August 11, 2006

In Reply Refer To: HSA-10/B-96B

Mr. Rick Mauer Outside National Sales Representative Nucor Steel Marion Inc. 912 Chaney Avenue Marion, Ohio 43302

Figure 12. Summary of results for NCHRP Report 350 test 3-11 on the Nucor Steel Marion cable barrier.

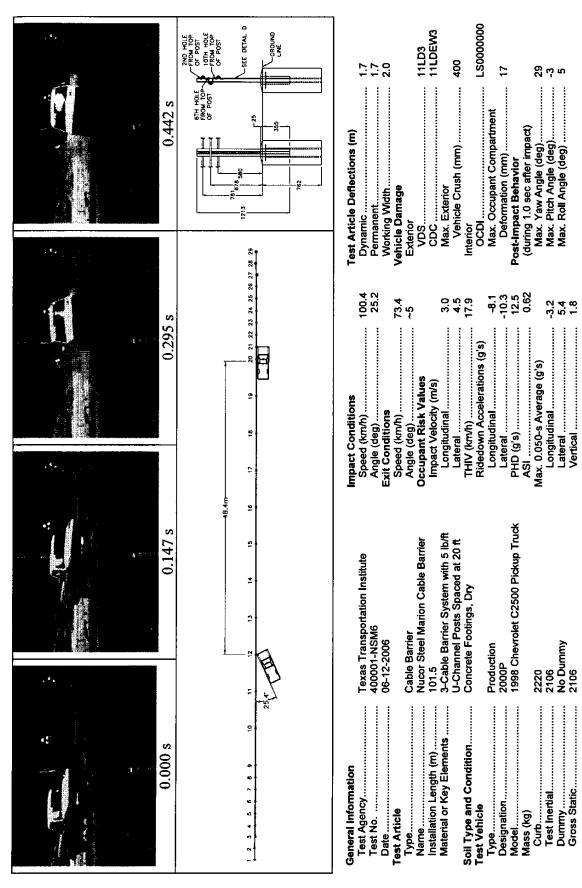
In your July 25, 2006 letter, you requested formal acceptance of the cable barrier described above, but supported by heavier 7.44 kg/m posts set on 6.1-m centers. These posts were again set in steel pipe sockets that were embedded in 300-mm diameter by 760-mm deep concrete footings. When impacted by the standard pickup truck at a nominal speed and angle of 100 km/h and 25 degrees respectively, the dynamic deflection was reported to be 1.7 m, as shown in the enclosed test summary sheet. Full details of the test are contained in the Texas Transportation Institute's July 2006 report entitled "NCHRP Report 3-11 of the Nucor Steel Marion Cable Barrier in Sockets Spaced at 20 ft with 5 lb/ft U-channel Posts".

Based on our review of the test report, the 3-strand cable barrier described above is acceptable for use on the National Highway System as a National Cooperative Highway Research Program Report 350 test level 3 barrier. Since both the anchor used in the test installation and
